**ADVANCED NUCLEAR FUELS CORPORATION**

License No. SNM-1227  
Docket No. 70-1257

**RESPONSE TO NRC "REQUEST FOR ADDITIONAL INFORMATION"**  
**DATED 09/11/89**

SPECIALTY FUELS BLDG  
 AUTOCLAVE PIT  
 WASTE DRUM STORAGE  
 ARRANGEMENT

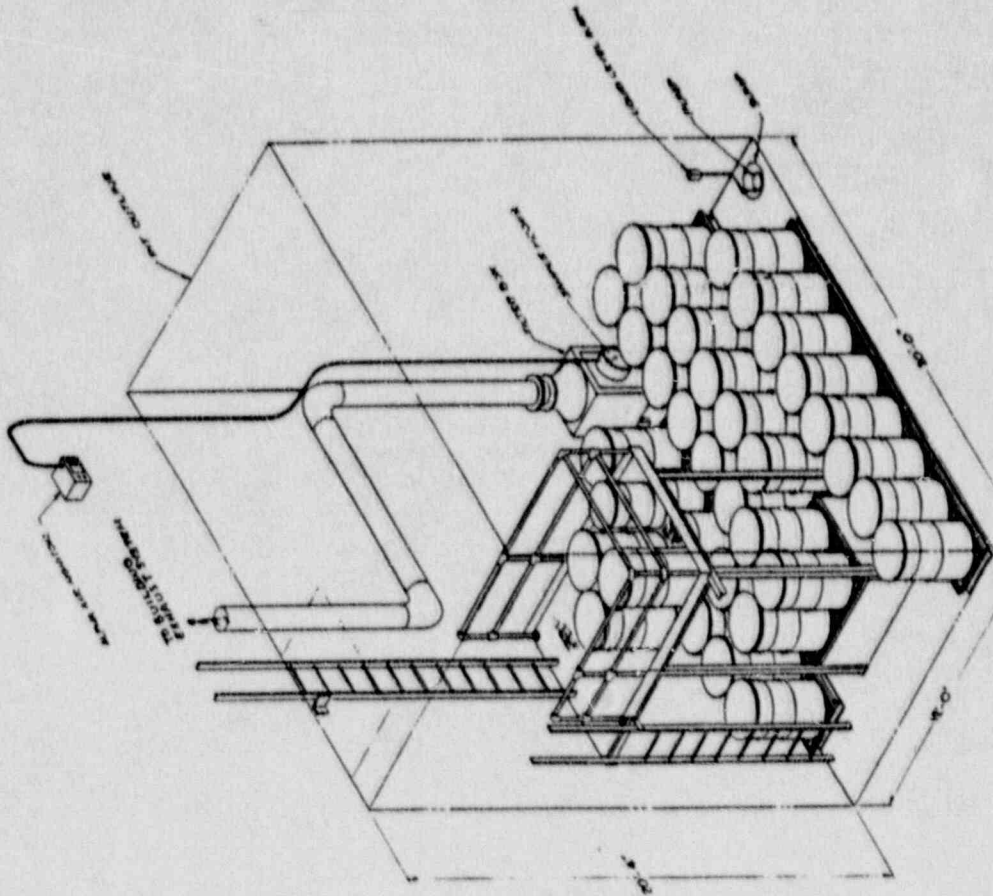
3. The pit in Room 162, Specialty Fuels Building is 12' wide, 20' long and 20' - 4 1/2" deep. The walls are 10" thick, reinforced concrete. The floor is 18", reinforced concrete. An 18" diameter by 18" deep sump for liquid collection and monitoring is located in one corner of the pit. The floor and walls are keyed and sealed with a continuous water stop. The concrete surfaces are finished in accordance with applicable sections of the American Concrete Institute Manual 301. The walls and floor are painted. The pit is covered with floor grating and overlaid with sheetsteel. Vertical ladders with a hinged door section provide access to the pit. See drawing ANF 608,736 for proposed arrangement.

4. There are no provisions for or plans to store materials, other than the plutonium contaminated waste drums in the pit. It is the practice at ANF to exclude the storage of material, in a special nuclear material storage area, which is unrelated to special nuclear material. As can be seen from the enclosed drawing, there are no provisions for storage of other than the plutonium waste drums.
